Moore Ranch Environmental Report
RAI Response Summary

Question TR 2.2.3.1 Surface Waters

Moore Ranch CPP Watershed
Figure 2.7.1-1a

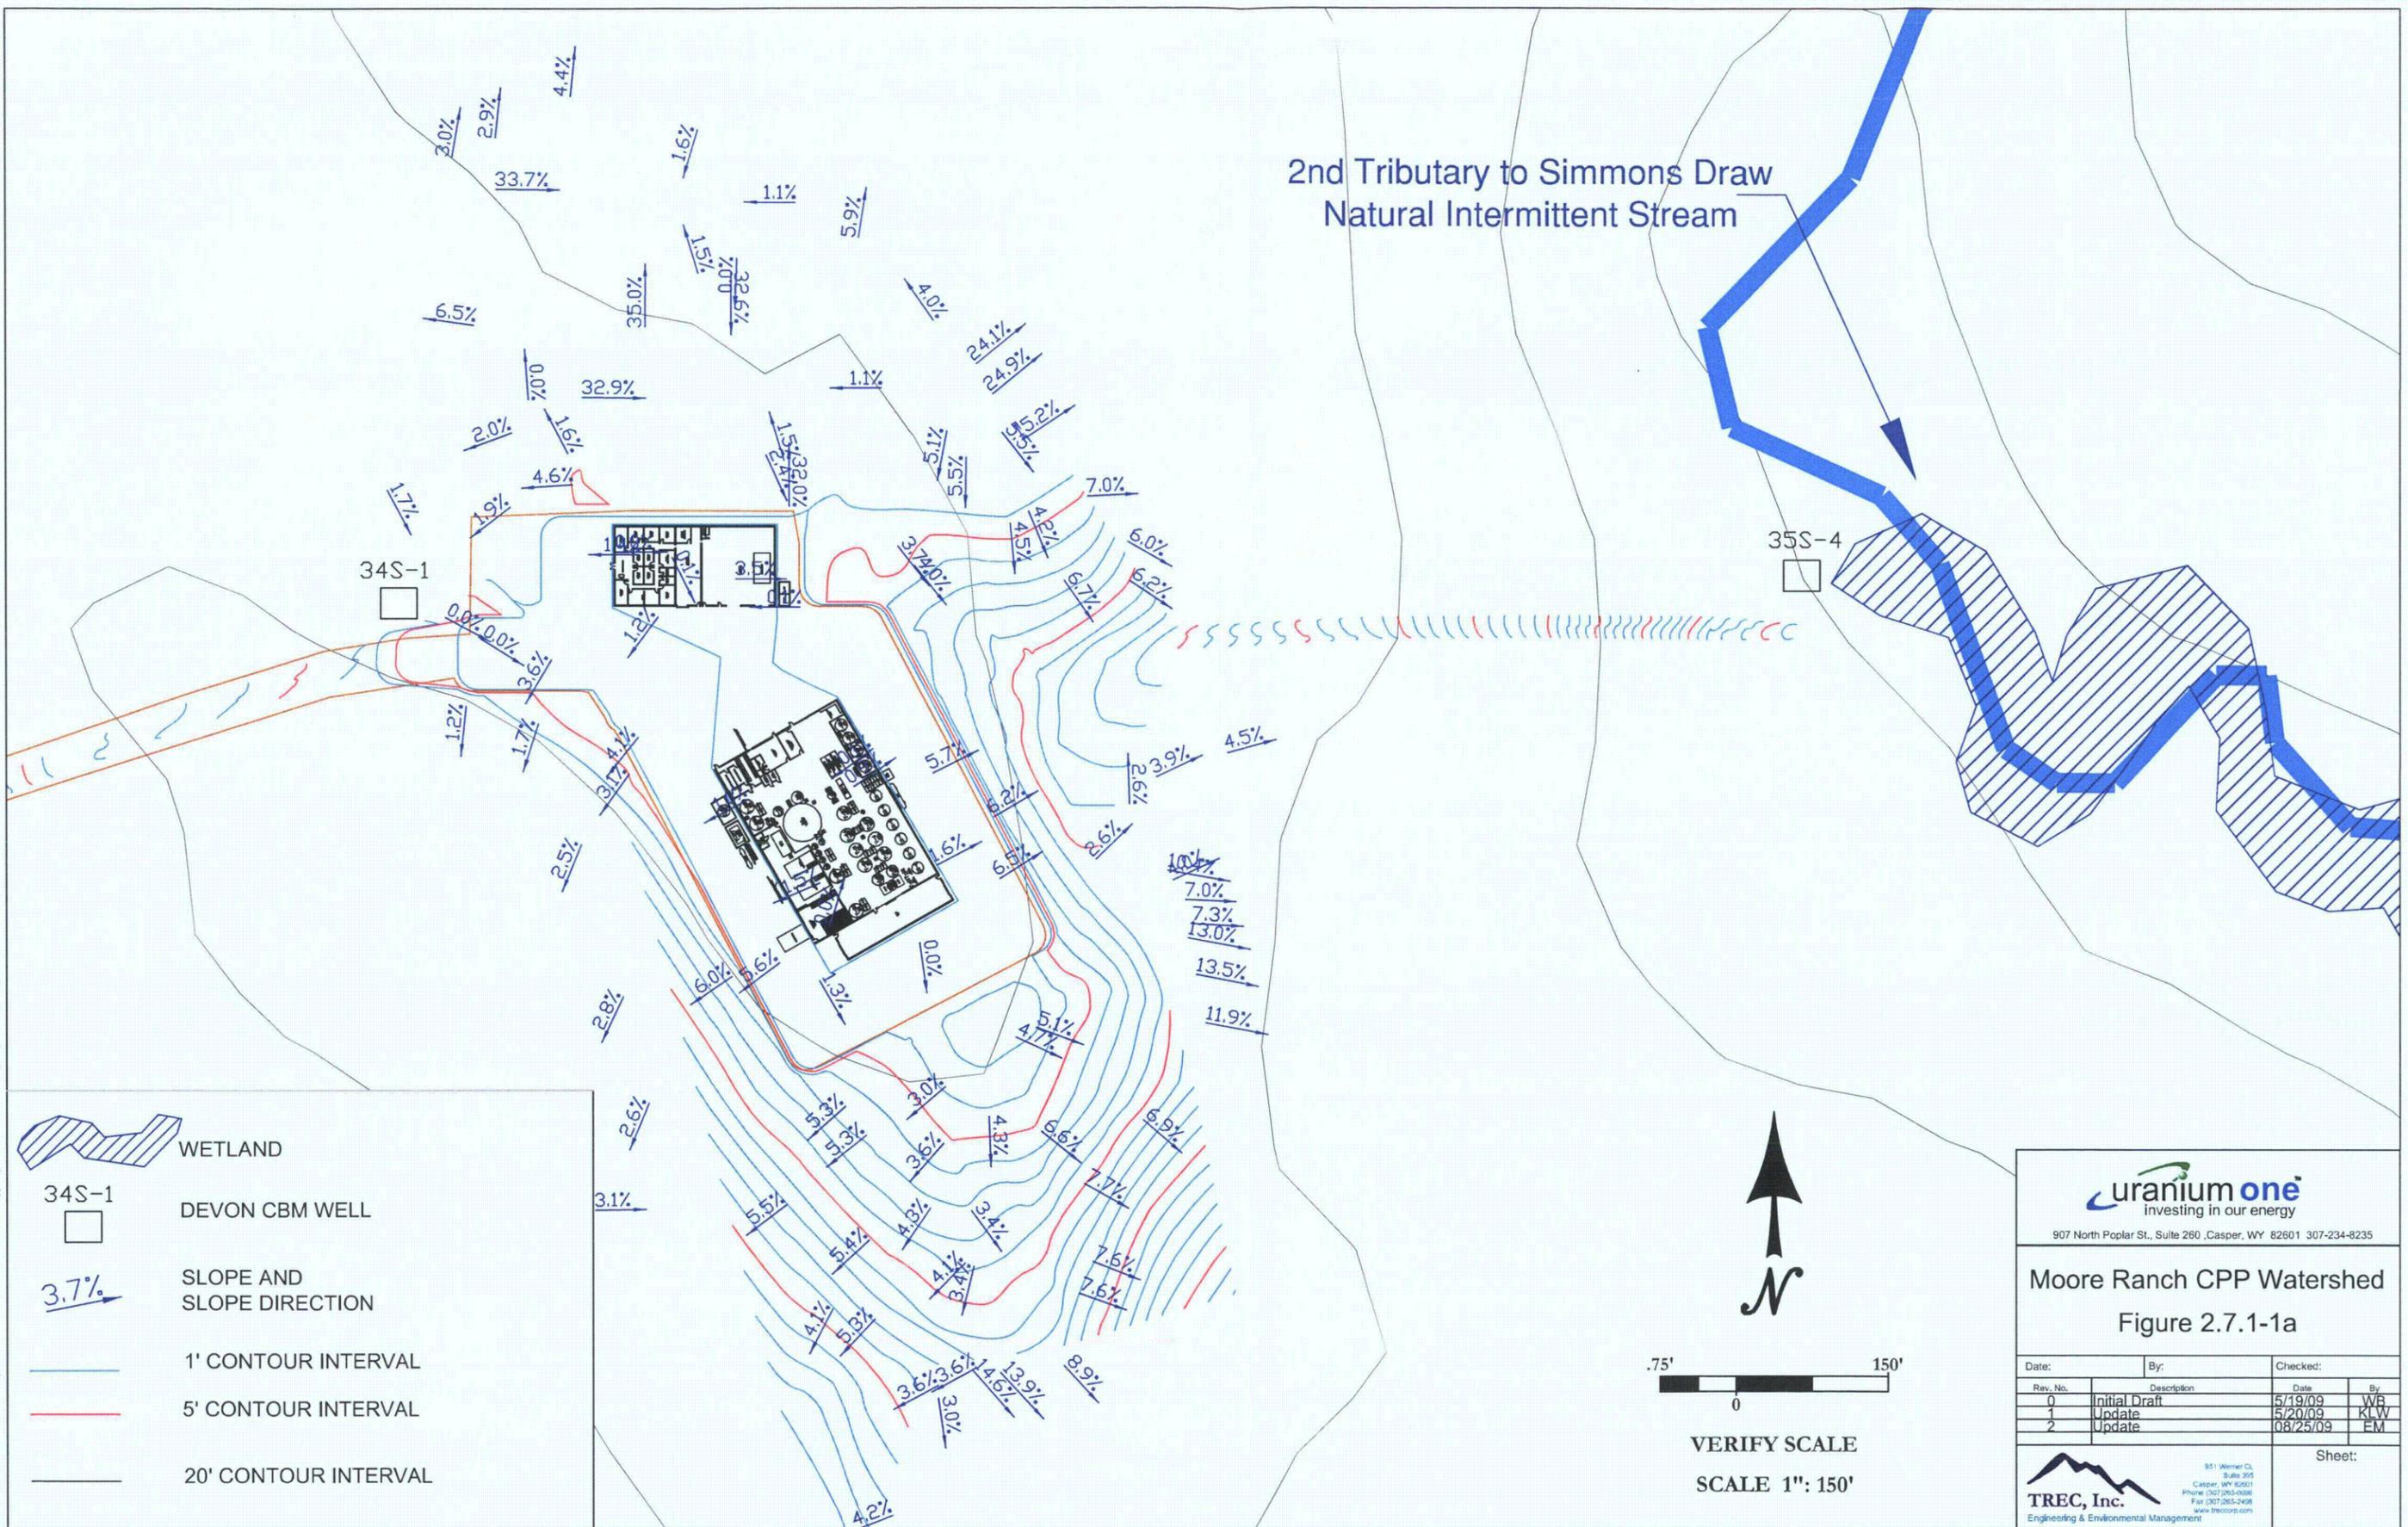
Question TR 2.7.1.2 Surface Water Runoff

The ISR facilities will discharge surface water in the form of runoff from the building roofs and parking area at the Central Plant site; this runoff will be discharged to existing drainage features. As requested, this information and a new Figure will be added to Section 2.7.1.2 Surface Water Runoff, of the Technical Report.

Moore Ranch ISR Project
Figure 7.2-2

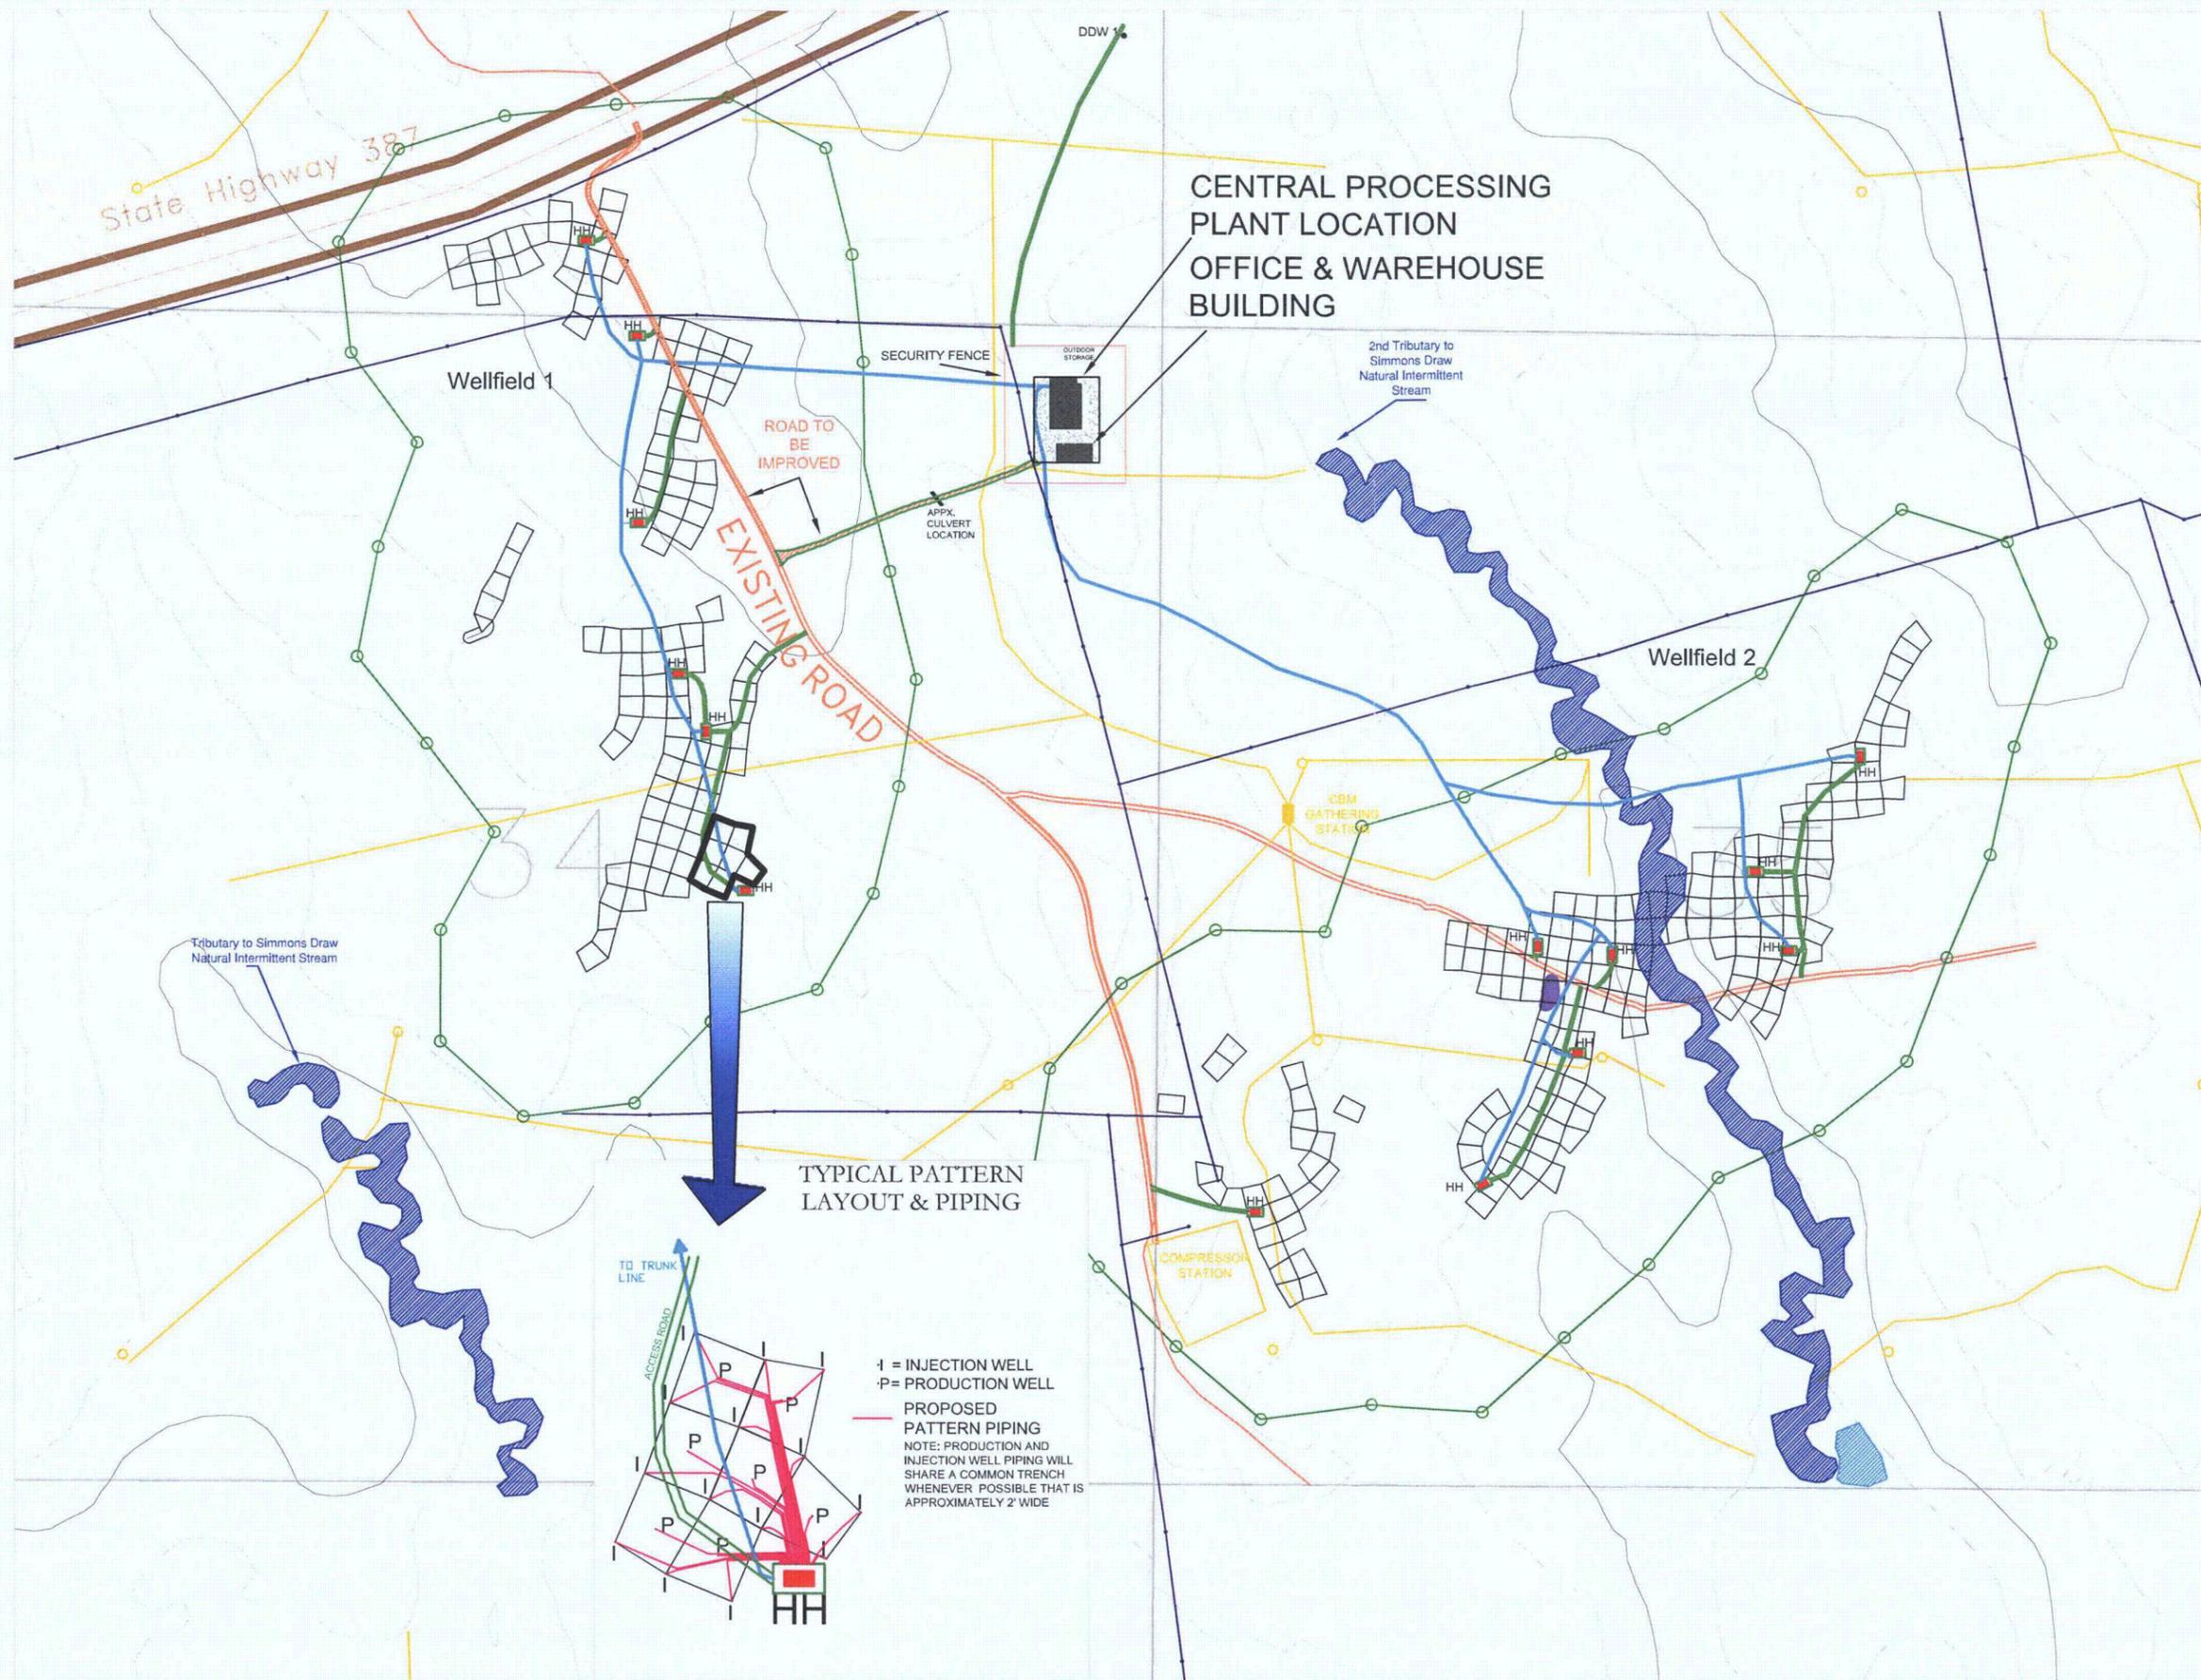
Please provide a detailed site plan showing proposed well locations, new road work, underground piping, utilities, and processing plants in relation to all channels, wetlands, and ponds. Estimate the number of injection and production wells that will be placed in surface water features. Also, estimate the number of new road crossings, pipe crossings, utility crossings, buildings, storage ponds, etc. that will be placed in surface water features, if any. Please provide justification for the encroachments, and steps taken to avoid, minimize, and mitigate such impacts.

Wellfield design has not been finalized. However, a site plan has been drafted and the figure and accompanying discussion will be included in revised section 7.2.9.2.2, Surface Water Impacts, of this Technical Report. Reference to the discussion will be made in the revision of Section 3.1.3 Wellfield Design and Operation.

The proposed Moore Ranch Project facilities have been located to minimize impacts to surface water features. Figure 7.2-2 shows the site plan of the Project area. Included in the site plan are the locations of State Highway 387, the current local access roads, power lines, CBM wells and associated CBM pipelines and gas distribution plants. In addition, the proposed Project facilities are shown on the site plan including the location of the Central Plant, the anticipated layout of the injection well patterns for Wellfields 1 and 2, and the location of the road to be improved from the main access road to the Plant. Local surface water features including two tributaries to the Simmons Draw and their associated wetlands are also shown in Figure 7.2-2.

Petrotek	10288 W. Chatfield Ave, Ste 201 Littleton, CO 80127-4239
URANIUM ONE	
Figure CR3.4.3.2. Depth to Water - 72 Sand Moore Ranch Uranium Project, Wyoming	
By: EPL Checked: HD File ID: figCR3432.srf Date: 7/28/09

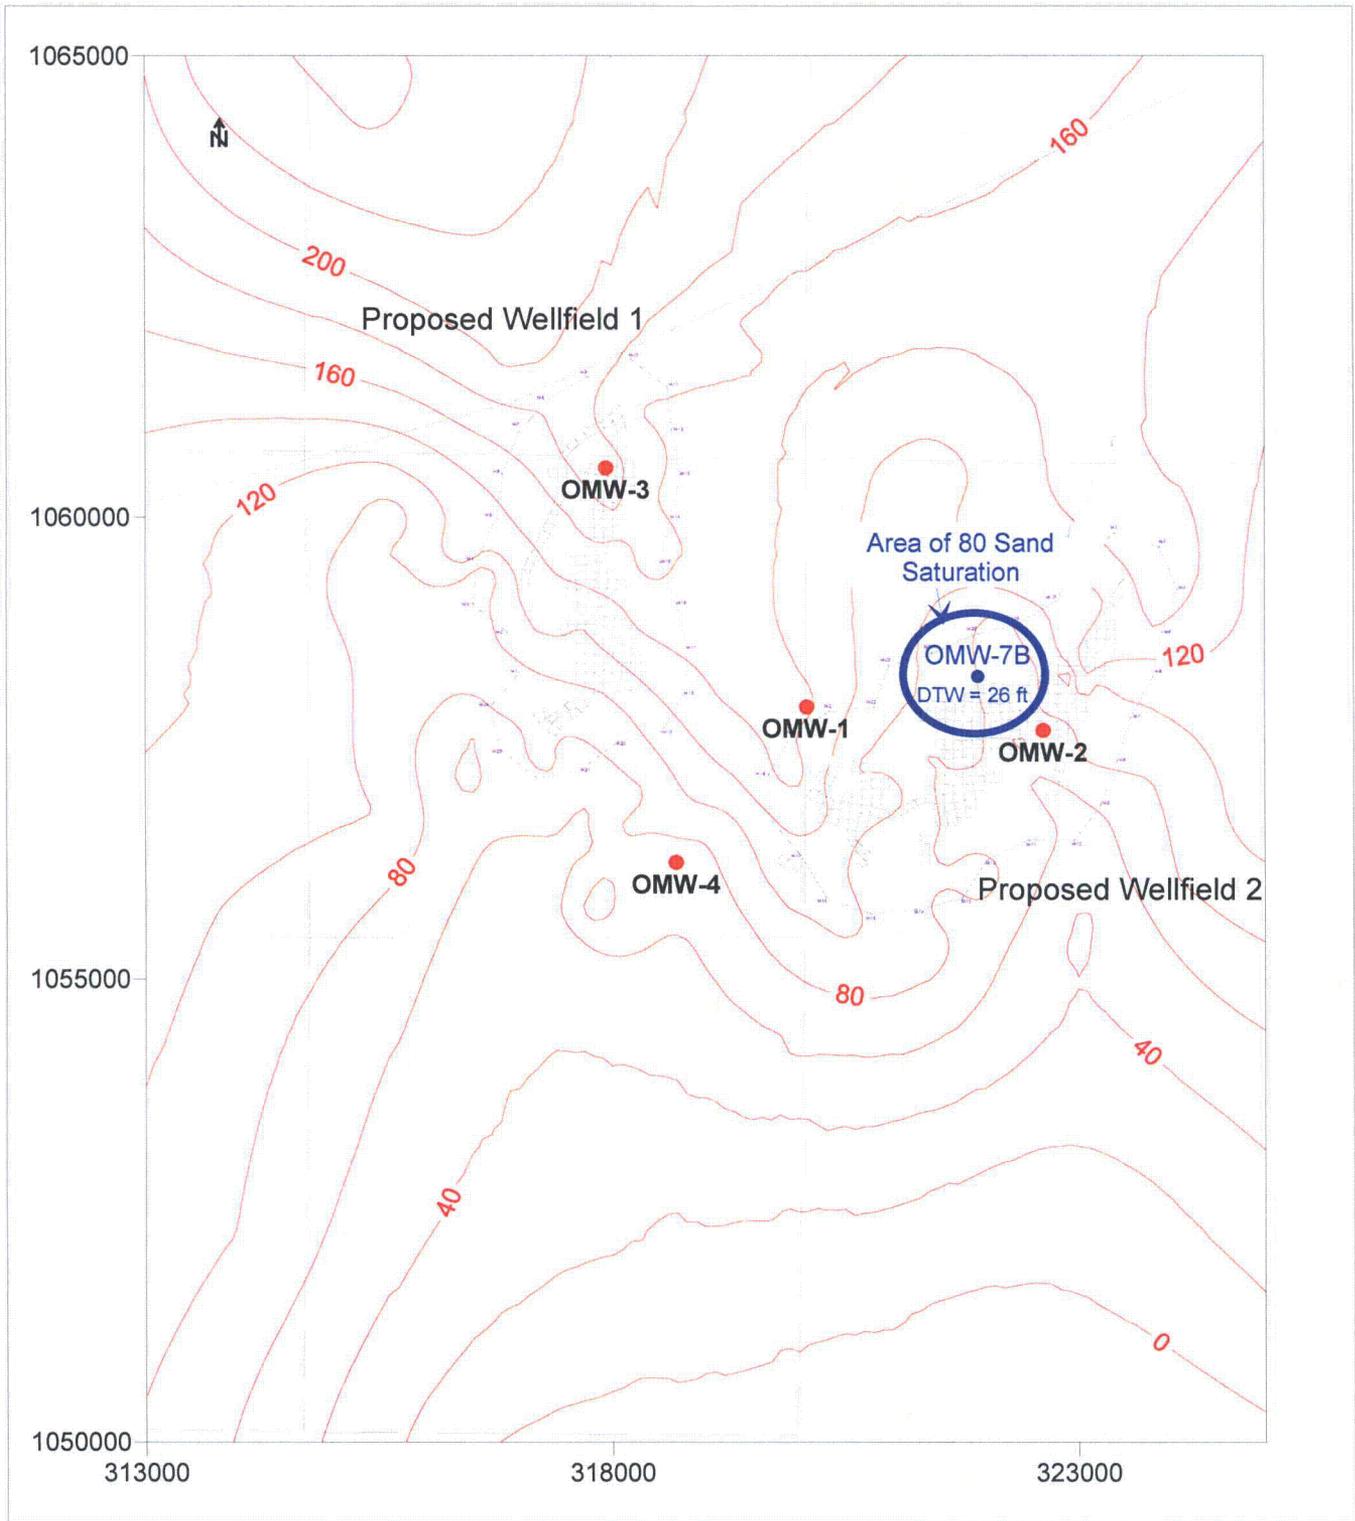
To assist in the evaluation of the impact of potential spills or releases at the surface on shallow groundwater, provide an isopach map depicting the thickness of the unsaturated zone above the shallow water table in the 72 sand throughout the license area.

An isopach map of the unsaturated zone thickness has been prepared and is included as Figure CR3.4.3.2. Additional drilling has indicated that the 80 Sand contains perched groundwater over small portions of the site. The area where saturated conditions are known to exist in the 80 Sand and the depth to water in that area has also been indicated on the map.
